CITY OF WESTMINSTER			
PLANNING APPLICATIONS COMMITTEE	Date 15 September 2015	Classification For General Release	
Report of Director of Planning		Wards involved Lancaster Gate	
Subject of Report	Flat 8, 33 Cleveland Square, London, W2 6DD		
Proposal	Creation of roof terrace to fourth floor rear closet wing roof with associated railings and privacy screen, insertion of rooflights into front pitch of main roof and lowering of cills at fourth floor level on front elevation; all associated with fourth floor Flat 8.		
Agent	A3Associates		
On behalf of	Mr R Keech		
Registered Number	15/05085/FULL	TP / PP No	TP/15025
Date of Application	08.06.2015	Date amended/ completed	08.06.2015
Category of Application	Minor		
Historic Building Grade	Unlisted		
Conservation Area	Bayswater		
Development Plan Context - London Plan July 2011 - Westminster's City Plan: Strategic Policies 2013 - Unitary Development Plan (UDP) January 2007	Outside London Plan Central Activities Zone Outside Central Activities Zone

Address: Flat 8, 33 Cleveland Square, London, W2 6DD

Proposal: Creation of roof terrace to fourth floor rear closet wing roof with associated railings and privacy screen, insertion of rooflights

FOR INFORMATION	
A3 Associates Ltd	
16 Daisy Lane London, W1A 1JF Tel: 020 7731 6463 lan@a3associates.net	
PROJECT	Flat 8, 33 Cleveland Square
DRAWING	Side Elevation & Section
SCALE	1:100 @ A3
DATE	May 15
DRAWN BY	1065 PL 06
REVISION	B
CHECKED BY

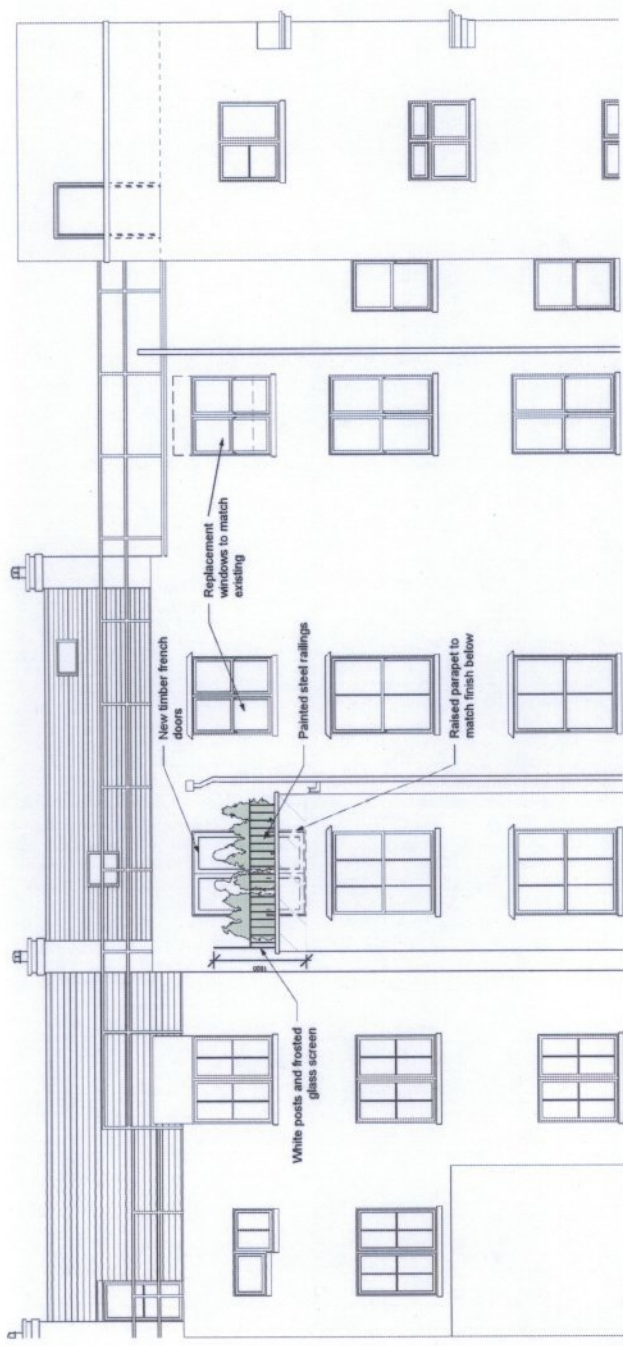
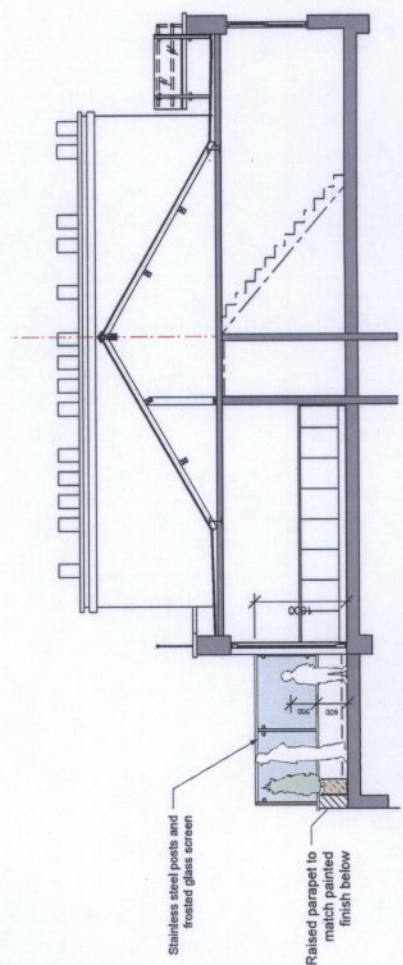
The physical alterations would be visible from the junction of Cleveland Square and Leinster Gardens, in addition to the rear of the terrace opposite at Leinster Gardens, and from the host building and 31 Cleveland Square. Whilst metal railings can be acceptable as a boundary treatment, the installation of glass balustrades at this height and location is normally resisted as it would create an alien boundary treatment that is uncharacteristic of the building within its immediate and wider setting.

The proposed location is considered to be particularly sensitive due to its location immediately adjacent to a group of listed buildings and its visibility from public views within the conservation area. In this context the glass balustrade would be an incongruous and alien feature that results in harm to both the setting of the adjacent listed buildings, and the wider conservation area. Furthermore, the introduction of two types of boundary treatments (glazed screen and steel balustrading) results in a confused appearance and visual clutter at roof level. The fact that the alterations would be visible from street level exacerbates this harm.

- Reason:
- 1 Because of its detailed design the glazed screen to be erected on the proposed roof terrace would harm the appearance of this building and fail to maintain or improve (preserve or enhance) the character and appearance of the Bayswater Conservation Area and the adjoining group of listed buildings at 31 - 22 Cleveland Square. This would not meet S25 and S28 of Westminster's City Plan: Strategic Policies adopted November 2013 and DES 5, DES 6, DES9, DES 10, DES 1 and paras 10.108 to 10.128 of our Unitary Development Plan that we adopted in January 2007. (X16AC)
- Reason:
- 2 The use of this area of roof as a terrace would lead to an unacceptable loss of privacy for people in neighbouring properties. This would not meet S29 of Westminster's City Plan: Strategic Policies adopted November 2013 and ENV 13 of our Unitary Development Plan that we adopted in January 2007. (X13AB)

FOR INFORMATION	
A3 Associates Ltd	
16 Dairy Lane, London, E16 3JN Tel: 020 7731 6463 info@a3associates.net	
Flat 8, 33 Cleveland Square	
PROJECT	
Front Elevation	
DRAWING	
1:100 @ A3	May 15
SCALE	DATE
1065 PL 05	A
DWG. NO.	REVISION
	CHECKED

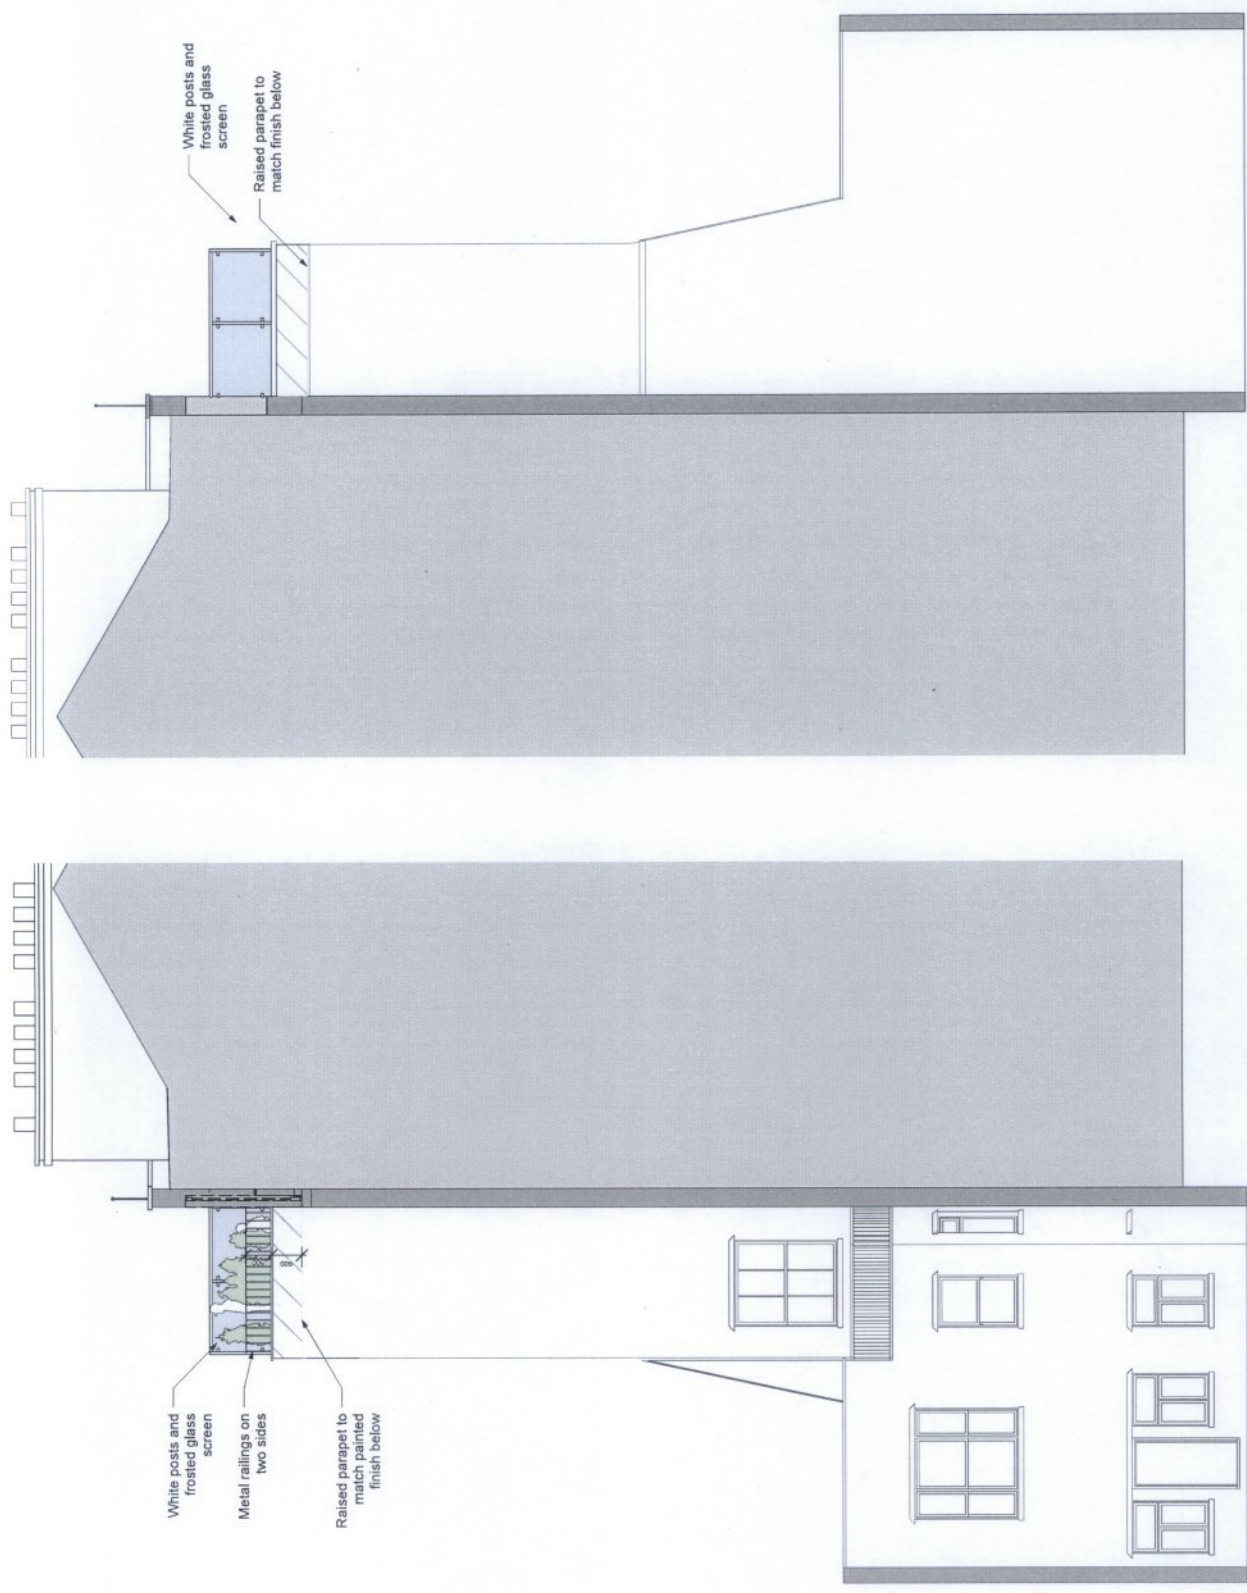
Objection on grounds that reducing level of cills would break uniformity of existing window lines. No objection to rear roof terrace.

The proposed lowering of the window cills to the front elevation are considered acceptable in design terms as the proposal would be consistent with other window openings in close proximity to the site, and preserves the existing hierarchy of windows which diminish in size from the first floor upwards, reflecting the characteristics of many of the other listed buildings in Cleveland Square.
